Detroit  
Edison

June 3, 1994  
NRC-94-0050

Subject: Detroit Edison Response to NRC Request for Additional  
Information - Control Center Heating, Ventilation and  
Air Conditioning (CCHVAC) System

FIGURE 1 - EFFECTIVE WIDTH AS A FUNCTION OF LOADING

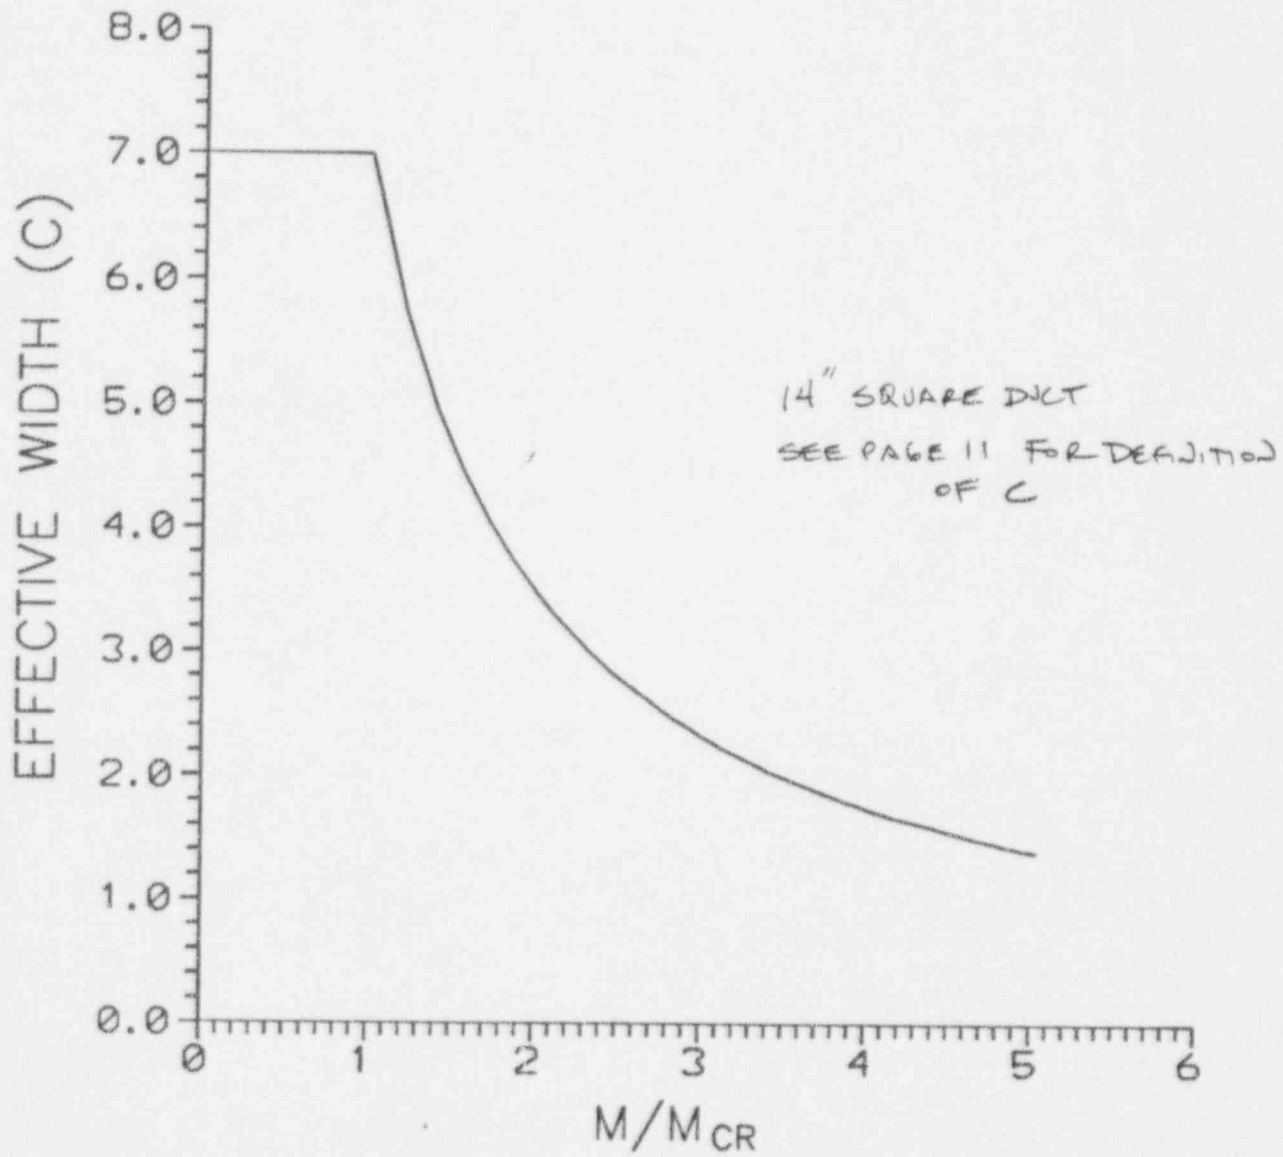
**NRC CONCERN 2:** Seismic analysis used full section properties rather than using "effective width" compressive flange as computed but not used. It thus appears that the internal moments and the deflections resulting from the seismic loading may have been underestimated.

FIGURE 1 DESCRIBES THE EFFECTIVE WIDTH OF THE COMPRESSIVE FLANGE AS A FUNCTION OF LOAD.

FIGURE 5.0.1

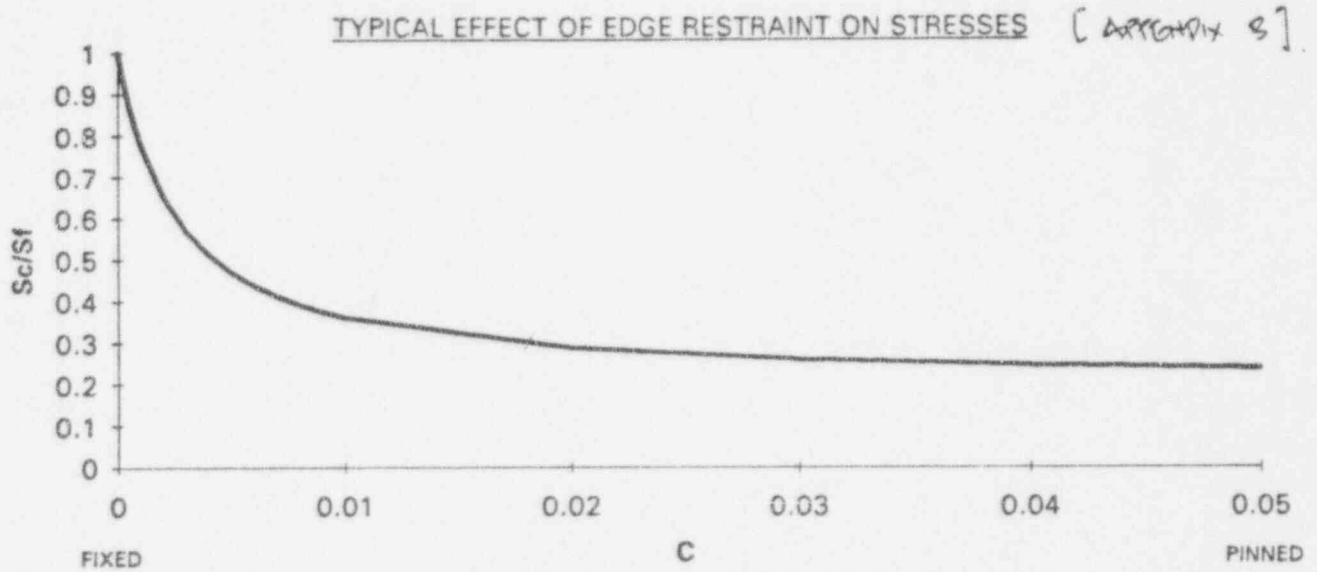
NRC CONCERN 3: The section properties and the stresses were calculated based on the thickness of the galvanized sheet metal. These should be based on the thickness of the bare metal.

ALTHOUGH THE DUCTING SYSTEM # 4316-6 AND # 4316-7 CAN BE POSSIBLY OVERSTRESSED BY A FEW PERCENT, THIS POSSIBILITY DEPENDS UPON THE RIGIDITY OF RESTRAINT AT THE EDGES OF DUCT PANEL. IT SHOULD BE NOTED THE ANALYSIS PERFORMED WAS BASED UPON THE ASSUMPTION THAT THE DUCT PANEL EDGES ARE FULLY FIXED. THE TYPICAL AS BUILT "PITTSBURGH LOCK" JOINTS ARE LIKELY NOT PERFECTLY RESTRAINED.

FROM THE THEORY OF PLATES AND SHELLS [4, PAGE 17], THE TYPICAL EFFECT OF EDGE RESTRAINT ON STRESSES CURVE WAS GENERATED AND ILLUSTRATED IN FIGURE 5.0.1. FOR AN UNIFORMLY LOADED RECTANGULAR PLATE WITH ELASTICALLY BUILT-IN EDGES, THE SLOPE OF THE DEFLECTION CURVE AT THE END OF THE STRIP PANEL IS PROPORTIONAL TO THE MOMENT AND DEPENDS ON THE EDGE RIGIDITY RESTRAINT FACTOR. IF THE RESTRAINT IS VERY RIGID, THE EDGE RIGIDITY RESTRAINT FACTOR BECOMES SMALL AND THE EDGE CONDITIONS APPROACH FULLY FIXED. IF THE RESTRAINT
